**PLANNING COMMISSION
MEETING AGENDA
SPECIAL/STUDY MEETING**

SUBJECT: PRELIMINARY SITE PLAN REVIEW (File Number SP 186 A) – Proposed Sunset Plaza CVS Pharmacy Drive-Through, Northeast Corner of Long Lake and Livernois (125 E. Long Lake), Section 10, Currently Zoned Neighborhood Node M District (Controlled by Consent Judgment)

TO: Brent Savidant
FROM: Zachary Branigan
DATE: May 20, 2011
RE: CVS Drive-Through, 125 East Long Lake Road

ENLARGED NEW AND DEMO SITE PLAN

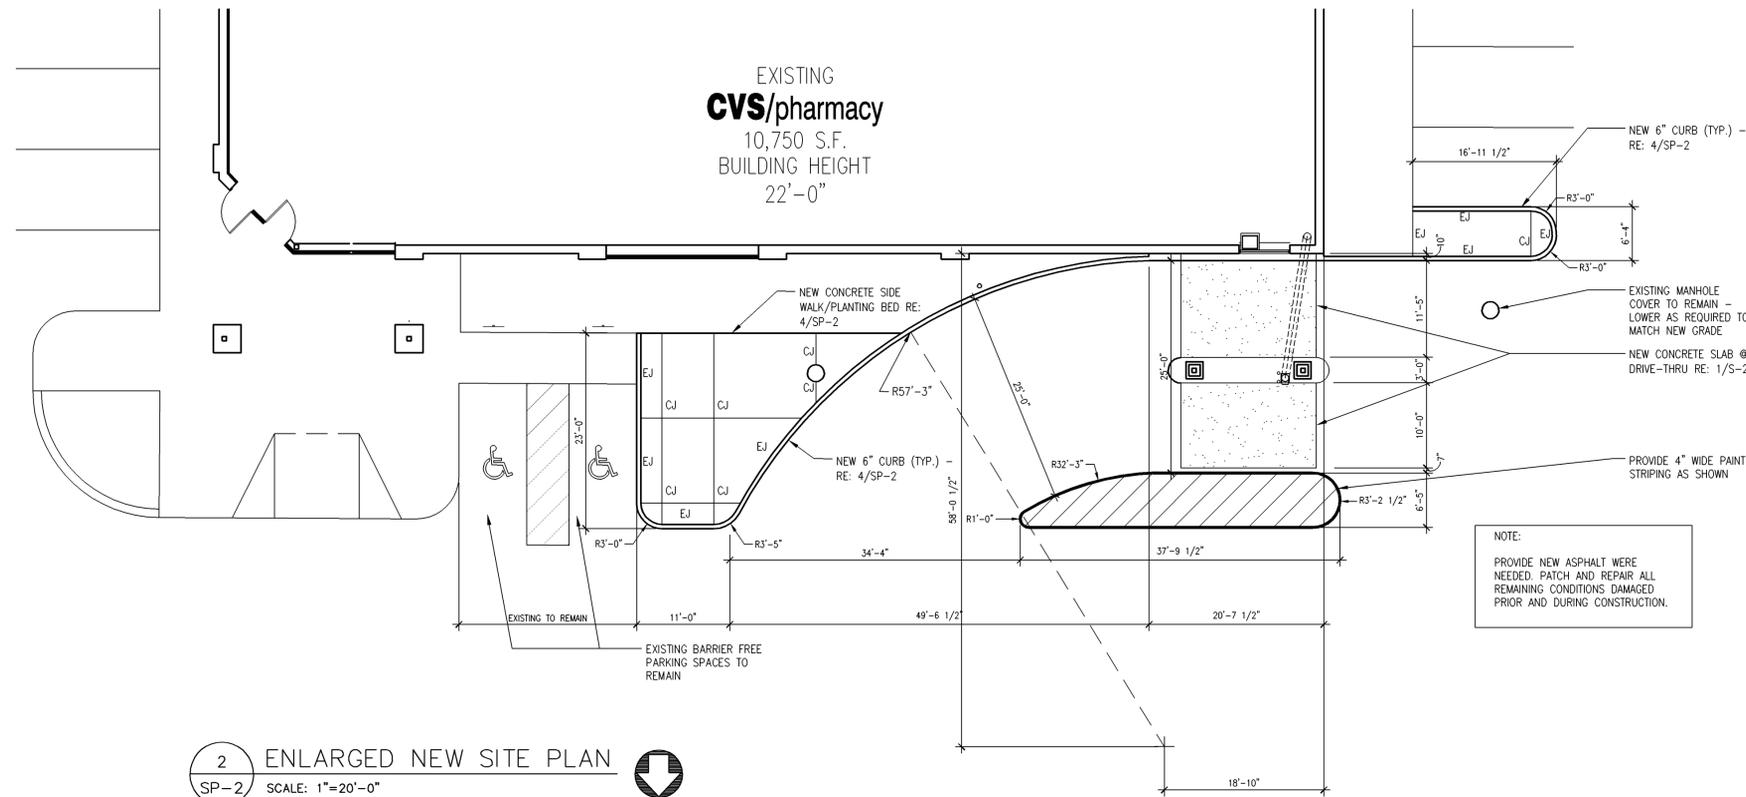
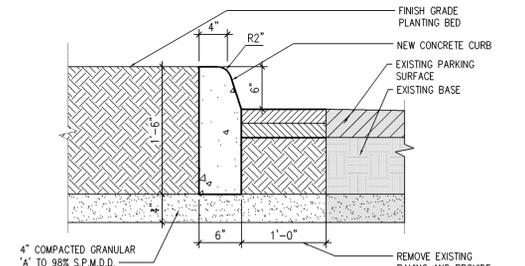
The proposed configuration of the drive-through is awkward. As designed, drivers would be forced to cross the oncoming traffic in the maneuvering lane heading west from the east entrance towards the main parking area. Further, there are two proposed windows (which we understand are for separated drop-off and pick-up functions), both of which exit next to one another and would presumably produce south-turning traffic movements. This double-loaded right turn area may cause conflicts as adjacent cars pull into the southbound traffic lane towards the site exit to Long Lake Road. Further, we are concerned that the only separation from the oncoming traffic is a striped area immediately south of the drive-through lanes. We suggest, at a minimum, that

additional directional striping be added to the maneuvering lanes to further establish the turning movements into the drive-through and that the striped island be replaced with a curbed landscape island to formally separate the maneuvering lanes from the drive-through lanes.

We also suggest that the separated drive-through windows be consolidated into a single window. While we recognize that the CVS preference is for two separate windows for drop-off and pick-up, we also understand that the traffic volume for these windows is exceptionally small and therefore a single window should suffice. We feel that the consolidation of these drive-through lanes into a single lane will alleviate some of our concern with regard to existing vehicles, and with vehicle conflicts entering the lanes.

We are also concerned that the proposed location for the barrier-free spaces may be in conflict with the proposed approach to the drive-through lanes. Vehicles wishing to use these spaces could become trapped by stacked cars using the drive-through or, at a minimum, be a hazard to vehicles attempting to cross the maneuvering lane and enter the drive-through lanes. We suggest the barrier-free spaces be relocated to the west side of the building by redesigning existing conventional parking spaces.

Section 6.10 establishes a series of requirements for all drive-through facilities. Section 6.10.A states that: "Drive-through facilities shall be designed in a manner which promotes pedestrian and vehicular safety." As noted above, we are concerned that the proposed design does not meet this criterion.

Further, Section 6.10.B states that: "Single-lane drive-throughs may be located at the side of a building. Multiple-lane drive-throughs shall be located in a manner that will be the least visible from a public thoroughfare." As noted above, the proposed facility includes two lanes. These lanes are proposed in a location where they would be most visible to Long Lake Road. For circulation purposes, our recommendation is that the lanes be reduced to a single lane. Compliance with this recommendation would also result in compliance with Section 6.10.B.

Finally, and also as noted above, Section 6.10.C.3, in Table 6.10, requires four stacking spaces per lane, which this proposal as designed does not meet. We are comfortable with fewer spaces, given the confined location, provided that the applicant reduces the number of lanes to a single lane and justifies the proposed number of stacking spaces. That said, if the lanes are consolidated and the barrier-free spaces are relocated as recommended, then sufficient area may exist to meet the minimum four-space standard.

The new drive-through facility would point at an existing single-family residential area. This area is already adjacent the shopping center, but would now also be subjected to the cars queuing in the drive-through lanes. There is an existing wall at this location; however, we are concerned that the wall does not provide a desirable or sufficient screening alternative given the increased intensity. Table 13.02-B, Landscape Screening Schedule, in Section 13.02.B, requires screening

While a wall does exist at this location, walls are intended to be used as a last resort for screening under the new Ordinance landscaping provisions. Section 13.02.B.3 states that: “Where a land use activity creates noise, light, dust or other similar nuisance that cannot be effectively screened by a landscape buffer, a solid opaque wall or fence may be required. Such wall or fence shall be a minimum of six (6) and a maximum of eight (8) feet in height as measured on the side of the proposed wall having the higher grade.” Section 13.02.B.4 goes on to add: “A combination of landscaping and a solid opaque wall or fence may be approved where such a combination provides more effective screening.” We feel the removal of parking spaces along the east property boundary adjacent the drive-through exit to allow for an enhanced screen incorporating the existing wall and the elements of screening alternative 3 would be a significant improvement in this critical area.

An existing water main is located directly beneath the proposed drive-through canopy. The City Engineering Department has stated that the water main must be relocated and provided a new easement, and that the existing easement must be abandoned.

1. The drive-through lanes must be consolidated into a single lane to permit a drive-through facility clearly visible from a major thoroughfare (Section 6.10.B)

2. Additional directional striping must be added to the maneuvering lanes to further establish the turning movements into the drive-through.
3. The striped island should be replaced with a curbed landscape island to formally separate the maneuvering lanes from the drive-through.

4. Four stacking spaces must be provided for each drive-through lane proposed (although only one lane is permitted in a location visible from a major thoroughfare, as noted above). Alternatively, we are open to the applicant providing documentation justifying a reduced number of stacking spaces.

5. The proposed barrier-free spaces must be relocated, preferably to the west side of the building, to eliminate potential conflicts with the drive-through.

6. An enhanced screen incorporating the existing wall and the elements of screening alternative 3 should be added to the east property boundary, potentially be removing spaces along the east boundary wall near the drive-through exit.

7. The existing water main must be relocated and provided a new easement, and that the existing easement must be abandoned.
